FBAG Comments on URS Work Plan Dated August 24, 2012

Fields Brook Superfund Site, Ashtabula, Ohio

FIGURE 1

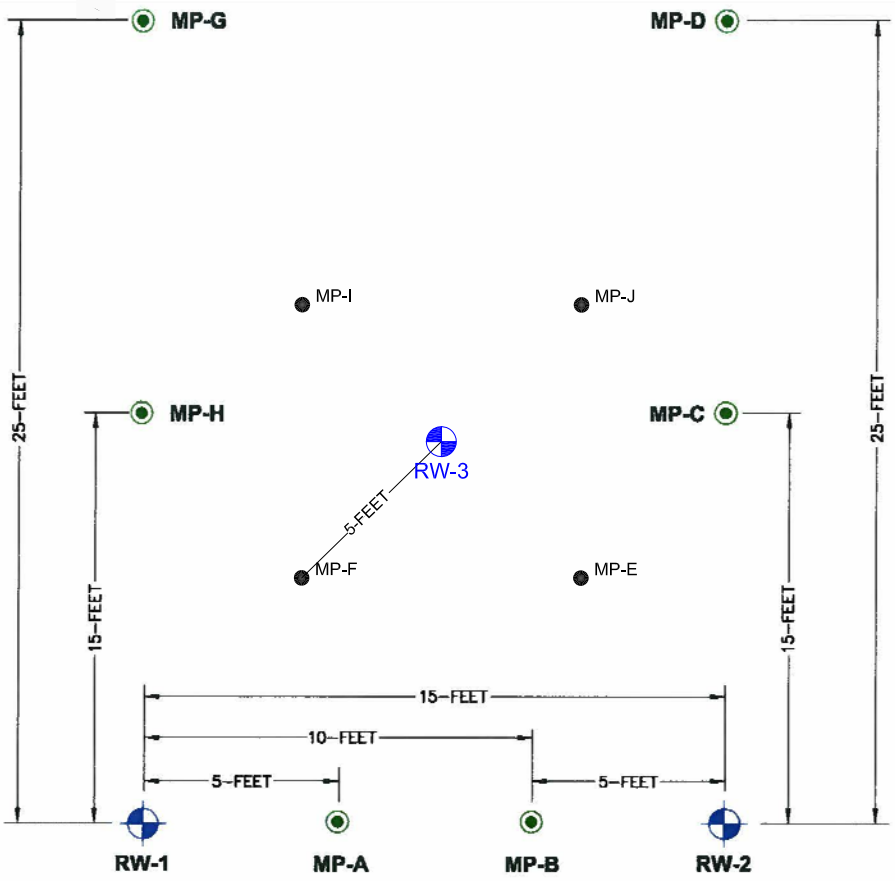
- The layout of the DNAPL recovery wells and associated monitoring points should be modified so that they are closer in proximity to each other and aligned in a manner that would allow for overlapping zones of influence and simulation of the full scale DNAPL remediation system. The schematic of the layout of recovery and monitoring points recommended by the FBAG is shown in the attached figure (Figure 1 – a modification of Figure 2-6 of the URS work plan).

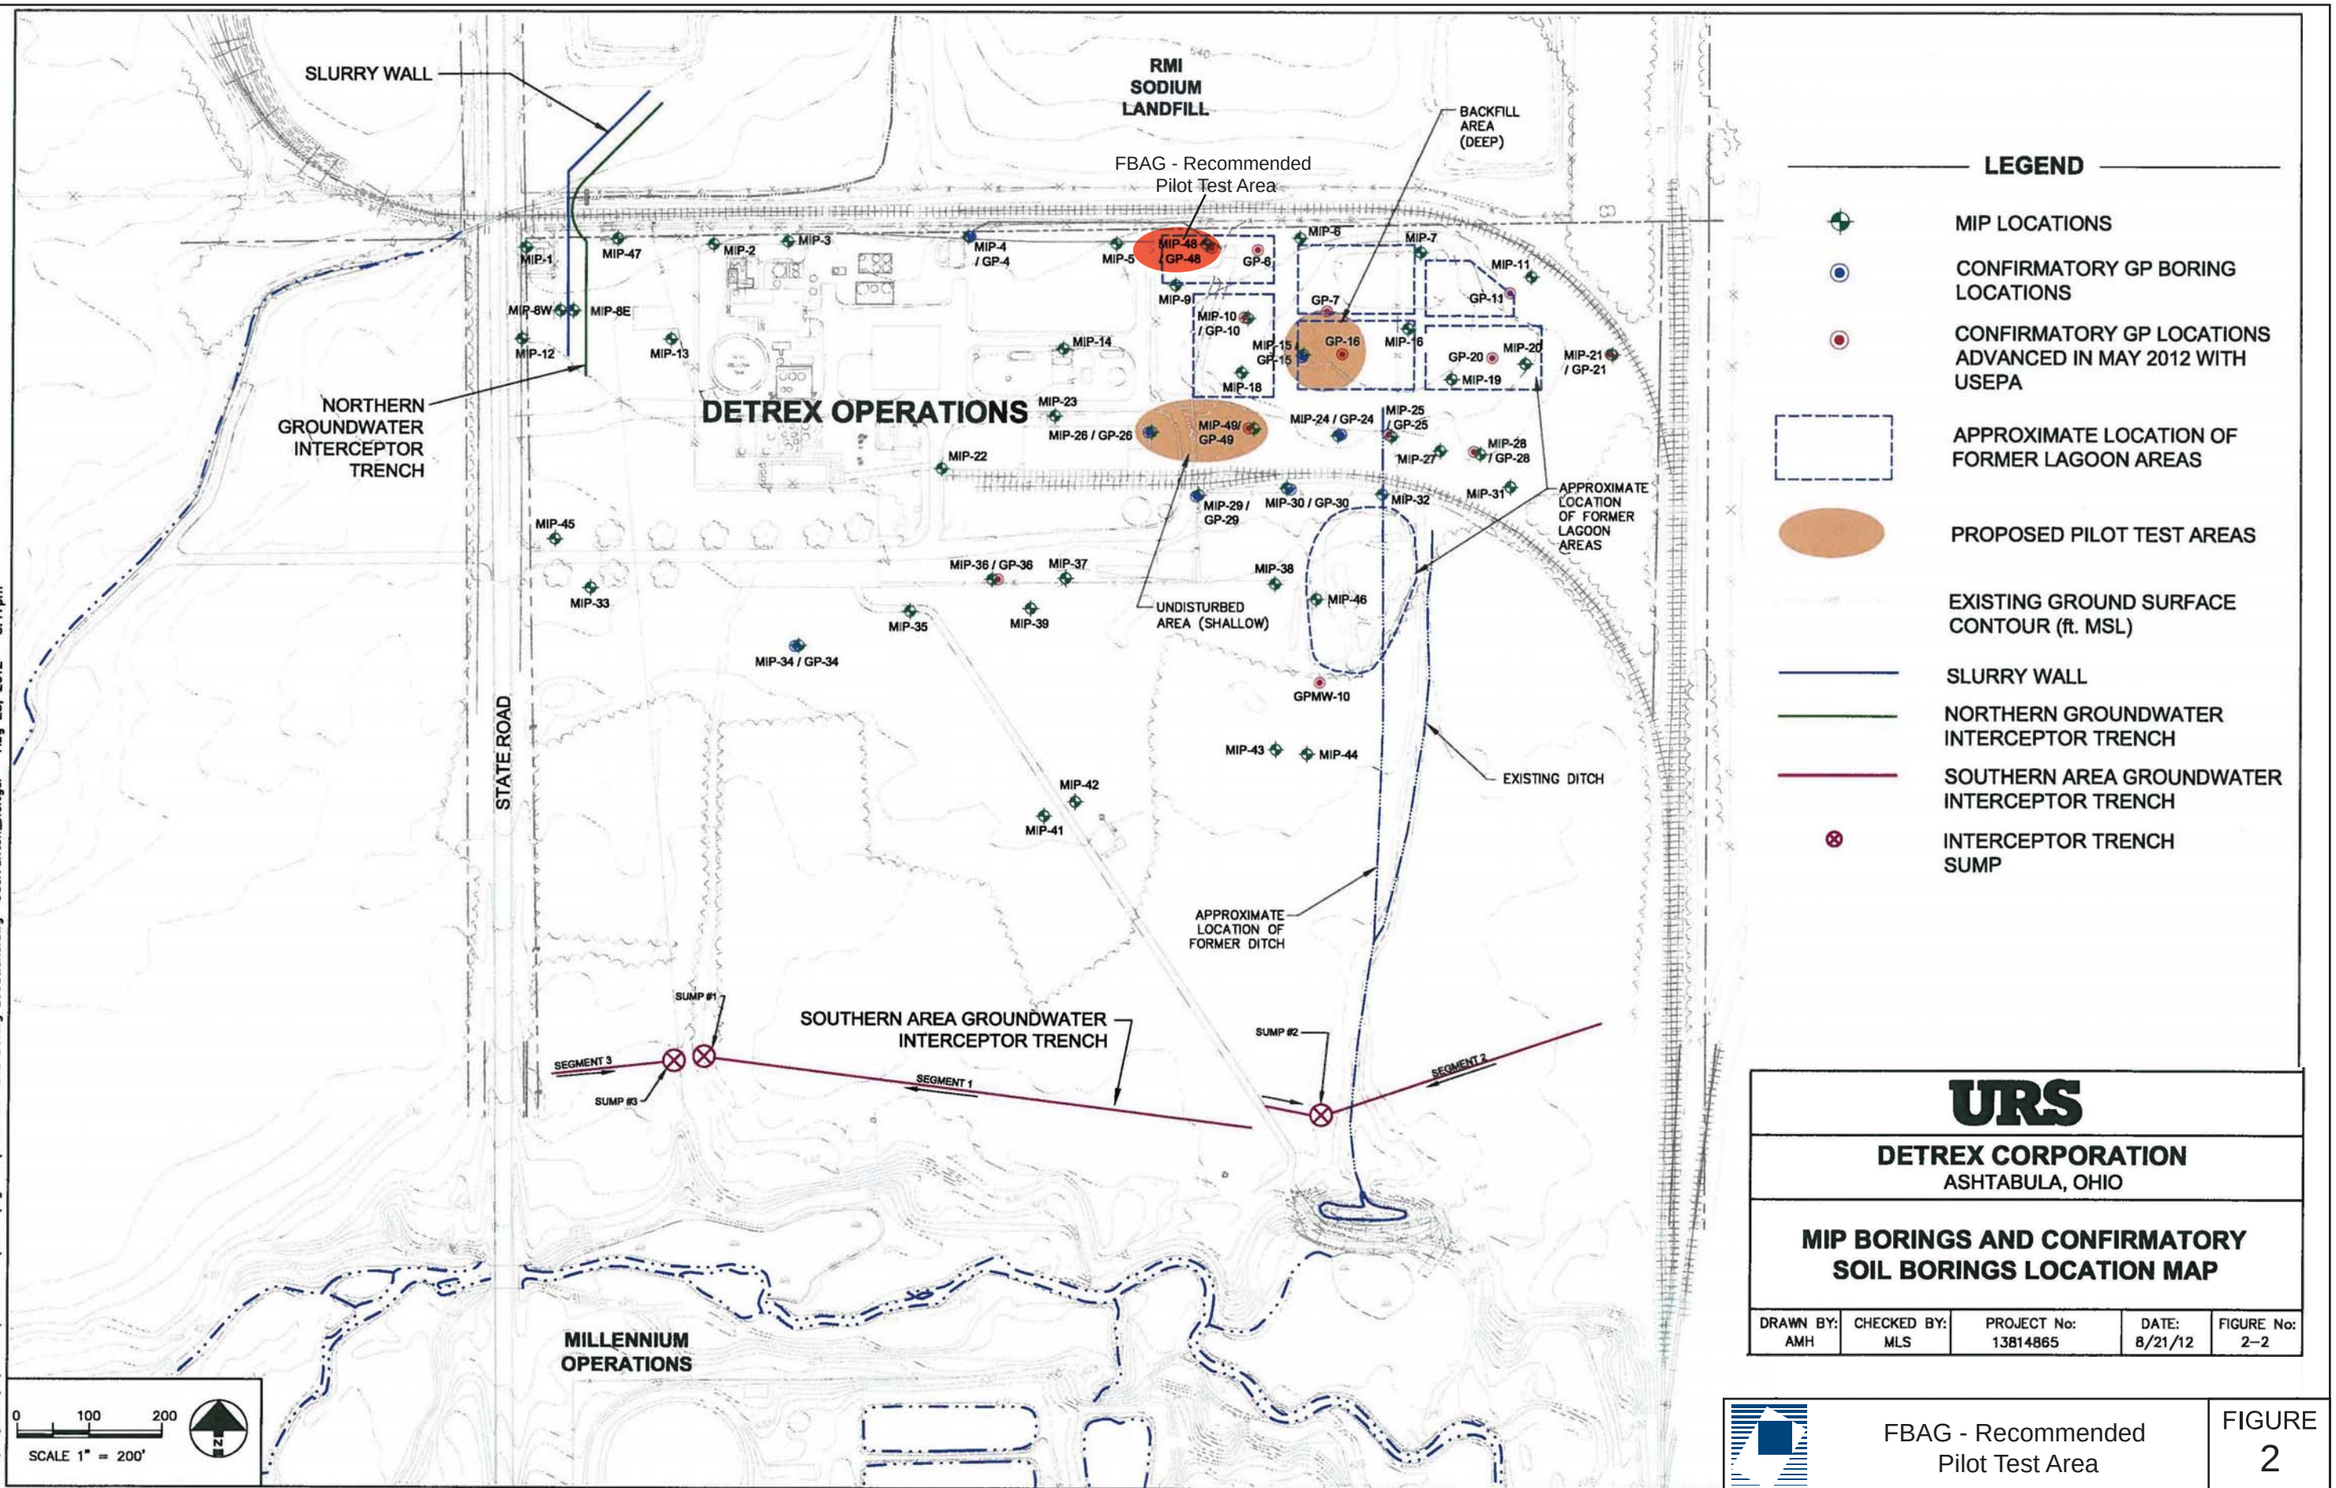
2. ***Location of Testing Areas***: The FBAG agrees with the Detrex-proposed approach of installing recovery wells both within and outside the backfilled lagoon area so that DNAPL recovery rates may be measured in both types of sub-surface deposits. However, a more important consideration is that the recovery wells be installed in impacted areas, which have previously shown evidence of potentially mobile DNAPL. The proposed testing area within the backfilled lagoon is appropriate, given that significant evidence of DNAPL contamination was observed at GP-15 and GP-16 during the recent Membrane Interface Probe (MIP) investigation. The FBAG also recommends that recovery wells be installed in the northern portion of the lagoon area (Figure 2 – a modification of Figure 2-2 of the URS work plan), where significant thicknesses of DNAPL have been consistently observed in the past (monitoring wells RMW-1 and RMW-3), and evidence of significant DNAPL contamination was found during the recent MIP investigation (GP-49). This would be a preferred location to the proposed area south of the lagoons.
